Determination 2013/020

The refusal to issue a code compliance certificate for a 16-year-old garage at 25 David Crescent, Karori, Wellington

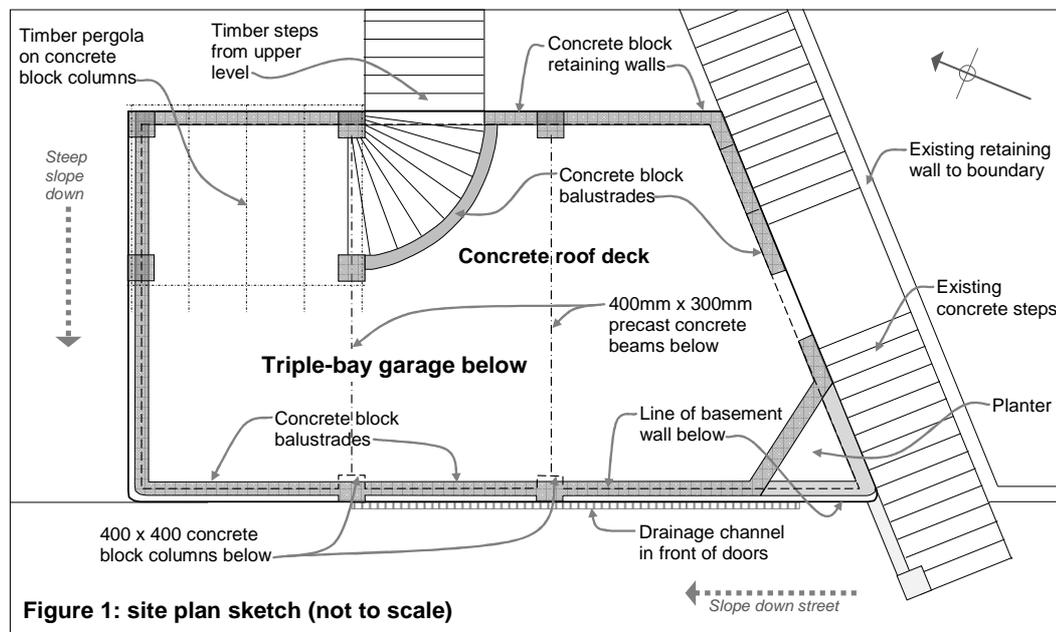
2.1 The building work consists of a single-storey detached garage set into the face of a steep west-sloping site in a very high wind zone for the purposes of NZS 3604⁴. The garage provides parking for three cars, with a concrete slab and foundations, reinforced masonry retaining walls to three sides, and a concrete roof slab above as shown in Figure 1.

2.2.1 The building structure is specifically designed; with precast concrete beams supported on reinforced masonry columns. The roof comprises a proprietary concrete floor system formed from prestressed concrete ribs, timber infills and a 75mm thick insitu concrete topping slab, with falls towards the southeast corner. The roof slab has been designed to support a superimposed load of 2.0 kPa.

2.2.2 The retaining walls step up at the steep slope, with the rear wall rising to about 2.6m above the roof deck slab in order to retain the balance of the excavated face and to form a garden area. External waterproofing to the retaining walls, as described on

the drawings is two coats of liquid-applied bitumen-based damp proof membrane overlaid with 250 micron polythene sheet, which is protected by polystyrene sheets.
